**Re: A K-4 CLASSROOM ADDITION BUILDING**

**ADDENDUM #3**

April 21, 2017

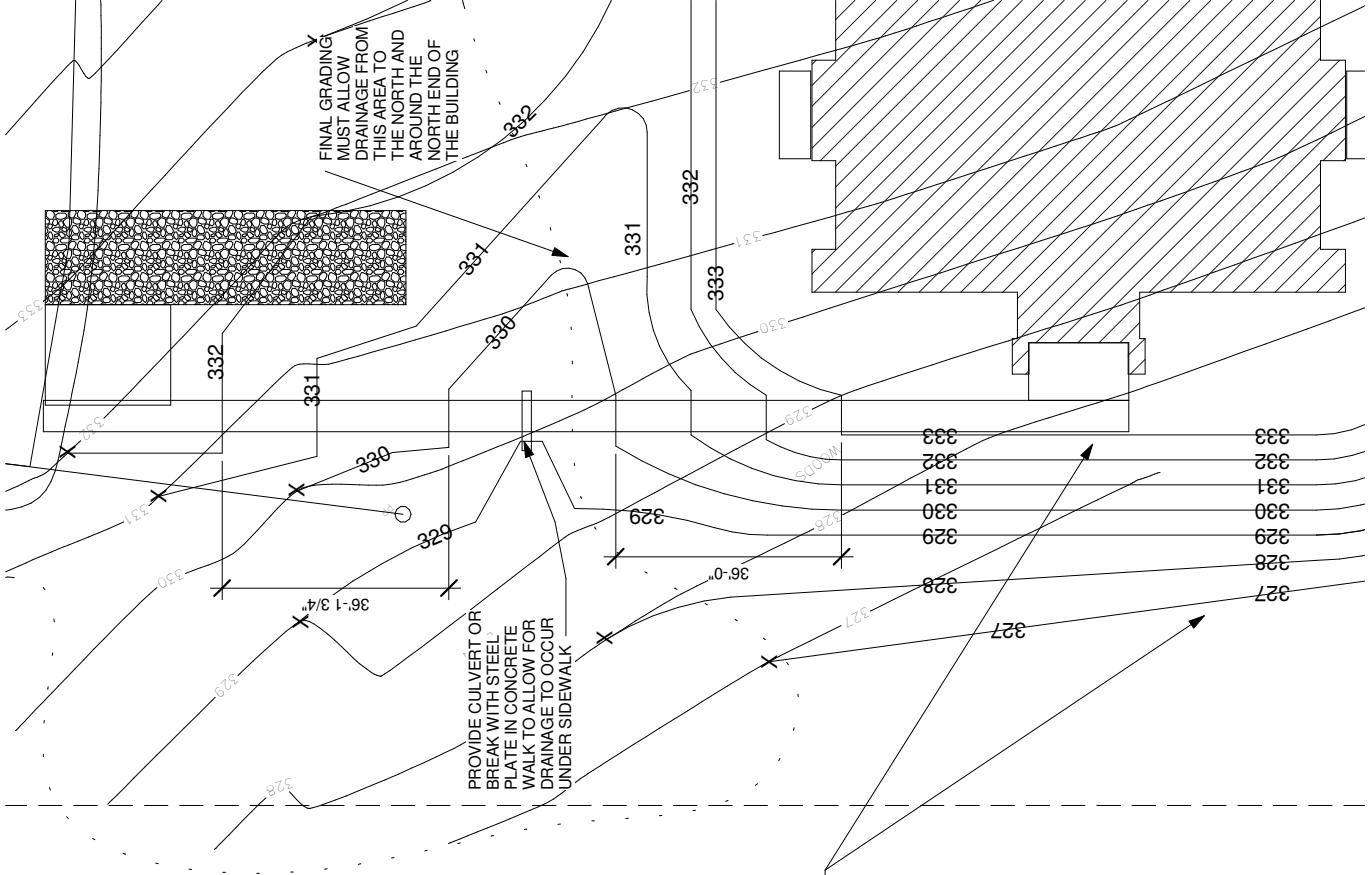
2. NORTH EXTERIOR WALKWAY- In reference to the sidewalk to the handicapped parking area at the north end of the building - see the attached sheet for clarification of walkway elevations and the new grading

GRADES SHOWN ON THIS PLAN ARE APPROXIMATE FINAL GRADES. CONTRACTOR SHOULD EXPECT SOME FIELD ADJUSTMENT FOR MINOR VARIATIONS IN THE EXISTING SURVEY AND ACTUAL CONDITIONS IN THE FIELD.
